**Technical News 160**  
**November 2014**  
**Strictly Confidential**

<b>Contents</b>		
<b>Item</b>	<b>Subject</b>	<b>Model Affected</b>
Item 1.	Frame Bolt Tightening Sequence	Tiger Explorer and Tiger Explorer XC
Item 2.	New Harness and Harness/Gear Position Sensor Parts Kit	Tiger Explorer and Tiger Explorer XC
Item 3.	Panniers	Trophy SE
Item 4.	Instrument Pack Washer	Various
Item 5.	Side Stand Fixing	All Thunderbird 1600 cc and Thunderbird 1700 cc Models
Item 6.	Lower Yoke Pinch Bolt Tightening Sequence	All Models With Two Lower Yoke Pinch Bolts Per Fork Leg
Item 7.	Update to Service Manual Full Specifications	Speed Triple, Speed Triple R from VIN 461332, Sprint ST, Sprint GT, Tiger 1050 and Tiger Sport
Item 8.	Crankcase Spares Kit - Update to VIN ranges specified in Technical News 151, Item 11	Speed Triple, Speed Triple R, Sprint GT and Tiger 1050
Item 9.	Sliding Caliper Seal Kit	Various

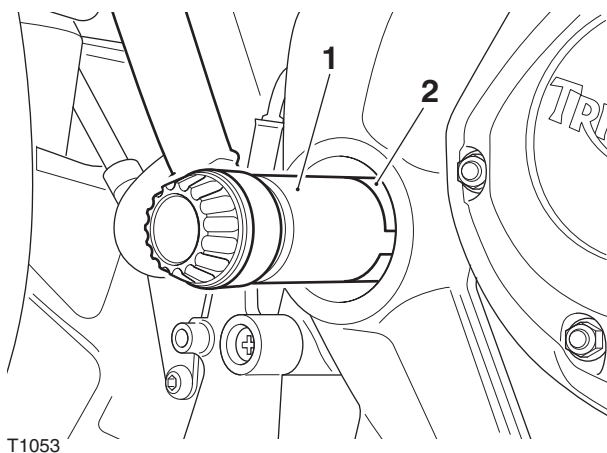
The frame bolt tightening sequence and torque figures have been updated for the above models. When refitting an engine to the above models, follow the new frame bolt tightening sequence as described in the procedure below:

- Before starting this procedure, complete steps 1 to 6 of the engine installation procedure as described in the Service Manual.
  - The swinging arm's right hand pivot pin must be loosened before the frame bolts can be tightened.
1. Carefully remove the cover from the swinging arm's right hand pivot pin.
  2. Using the service tool Lock Ring Wrench, 38 mm T3880062, remove the locking ring from the right hand pivot pin.

1. Lock Ring Wrench, 38 mm T3880062
2. Locking ring
3. Loosen the right hand pivot pin but do not fully remove.

**Frame Bolts Exploded View**

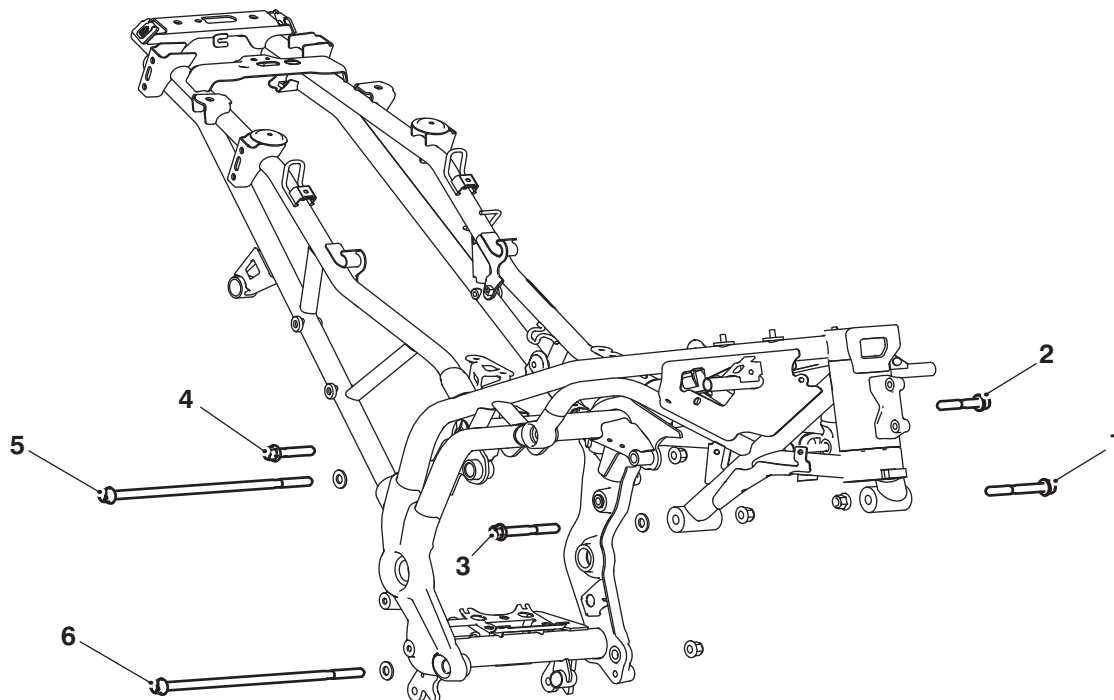
5. Temporarily fit the crankcase mounting bolts and washers to the left hand side of the frame.
6. Remove the right hand front cylinder head bolt and washer and temporarily refit to the left hand side of the mounting point.
7. Lubricate the threads of the new rear cylinder head bolts **only** with a smear of proprietary high temperature copper-based grease.
8. Fit the new right hand rear cylinder head bolt ensuring that the spacer is fitted between the cylinder head and frame. Do not fully tighten at this stage.
9. Fit the new left hand rear cylinder head bolt. Do not fully tighten at this stage.
10. Fit a new lock nut to the left hand front cylinder head bolt and tighten to **24 Nm**.
11. Tighten the left hand rear cylinder head bolt to **85 Nm**.

1. Left hand front cylinder head bolt
2. Left hand rear cylinder head bolt
3. Right hand front cylinder head bolt
4. Right hand rear cylinder head bolt
5. Upper crankcase bolt
6. Lower crankcase bolt

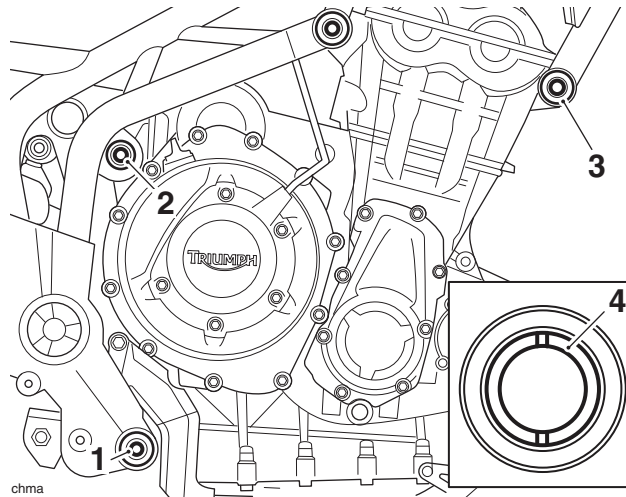
- 
12. Using tool Engine Mounting Adjuster Wrench T3880377, tighten the three adjusters in the following sequence.
    - Tighten the lower crankcase adjuster to **5 Nm** then, remove the lower crankcase bolt and washer and refit to the right hand side of the frame.
    - Tighten the upper crankcase adjuster to **5 Nm** then, remove the upper crankcase bolt and washer and refit to the right hand side of the frame.
    - Tighten the cylinder head right hand front adjuster to **3 Nm** then, remove the right hand front cylinder head bolt and washer and refit to the right hand side of its mounting.

13. Remove the support from beneath the engine.
14. Fit new lock nuts and tighten in the following sequence:
  - Upper crankcase mounting lock nut to **100 Nm**.
  - Lower crankcase mounting lock nut to **100 Nm**.
  - Right hand rear cylinder head bolt to **85 Nm**.
  - Left hand front cylinder head bolt and lock nut to **115 Nm**.
  - Right hand front cylinder head bolt and lock nut to **100 Nm**.

1. Lower crankcase adjuster
2. Upper crankcase adjuster
3. Cylinder head front right adjuster
4. Adjuster

**T2501116 - Kit, Harness and Gear Sensor - Tiger Explorer and Tiger Explorer XC up to engine number 596480****Parts Kit Contents**

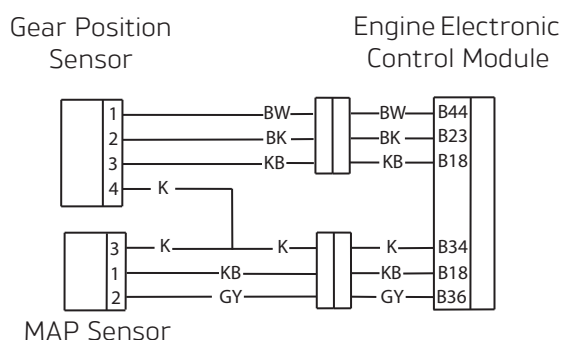
This new harness is now connected directly to the gear position sensor without the use of a fly lead.

A harness and gear position sensor parts kit has also been released for use when replacing the harness on the above models up to engine number 596480 that do not have the fly lead gear position sensor fitted.

### Circuit Diagrams

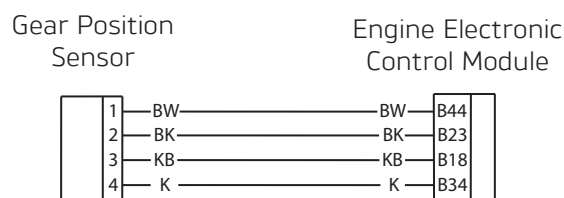
The gear position sensor pinpoint test procedure has also changed. The pinpoint test procedure for the new gear position sensor and old gear position sensors with a fly lead is as follows:

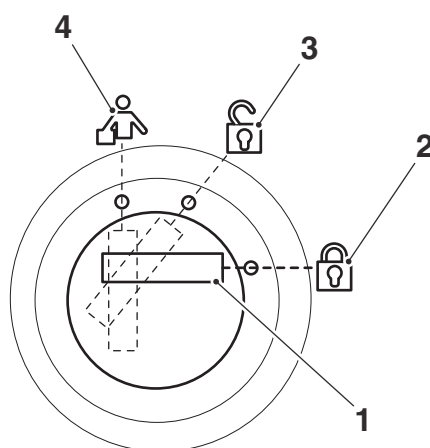
Panniers will not be supplied with the above models in the packing crate from VIN 657579. The panniers will be delivered to the dealers separately.

The panniers will be supplied assembled with only the lock barrel to be fitted. To fit the lock barrel, follow the procedure described below:

- **The lock barrel will only fit one way.**
1. Take a lock barrel and key (supplied with the motorcycle), insert the key into the barrel and push the barrel into position in the pannier until it clicks into place.
  2. Check the operation of the lock barrel.
  3. Turn the key to the LOCK position and remove the key.
  4. Fit the lock barrel to the remaining panier in the same manner.

1. Key slot, shown in the locked position
2. Lock position symbol
3. Unlock position symbol
4. Release position symbol

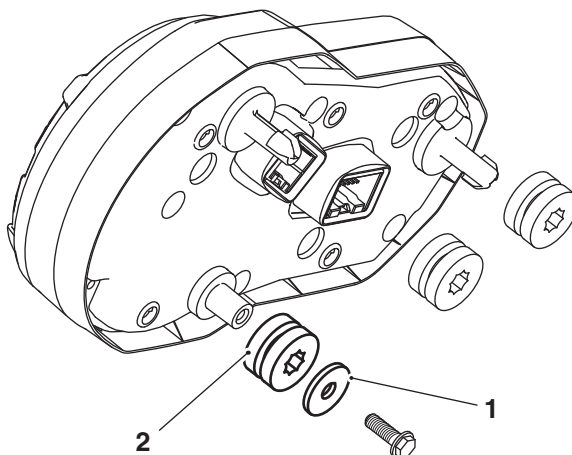
A revised washer with an increased outside diameter has been introduced on the above models and is retrofittable. If the instrument pack is removed or replaced for any reason, a larger 18 x 1.6 mm washer should be fitted.

1. Washer 18 x 1.6 mm
2. Grommet

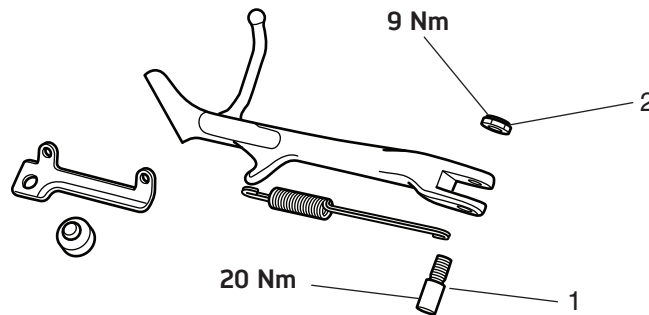
The torque figure for the side stand bolt on the above models has changed to **20 Nm** and the side stand lock nut has changed to **9 Nm**.

1. Bolt
2. Lock nut

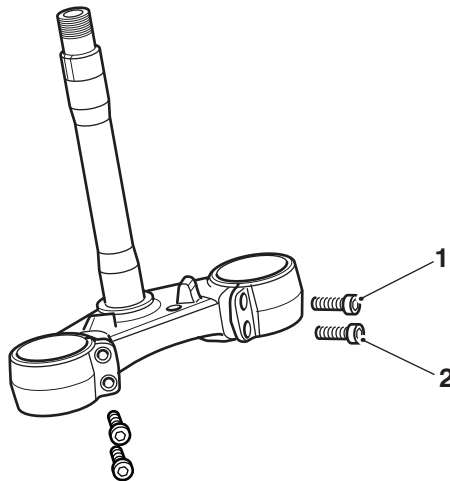
A new lower yoke pinch bolt tightening sequence has been released for all models with two lower yoke pinch bolts per fork leg.

1. Tighten the upper pinch bolt to the torque specified in the Service Manual.
2. Tighten the lower pinch bolt to the torque specified in the Service Manual.
3. Retighten the upper pinch bolt to the torque specified in the Service Manual.

1. Upper pinch bolt
2. Lower pinch bolt

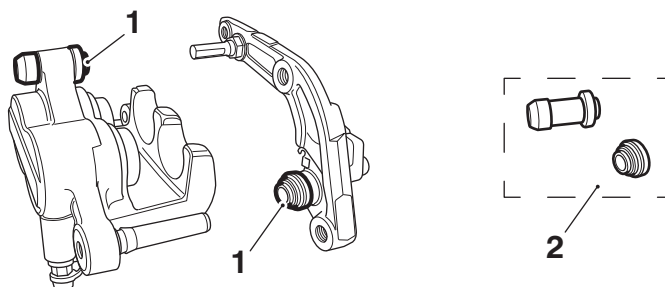
A parts kit containing sliding caliper pin gaiters has been released. The kit can be used to replace sliding pin gaiters on the calipers identified for the following models:

When servicing the brake calipers identified for the models listed above, inspect the sliding pin gaiters for damage and replace if necessary using parts kit T2021707.

1. Sliding pin gaiters - Street Triple left hand front caliper shown
2. Kit T2021707
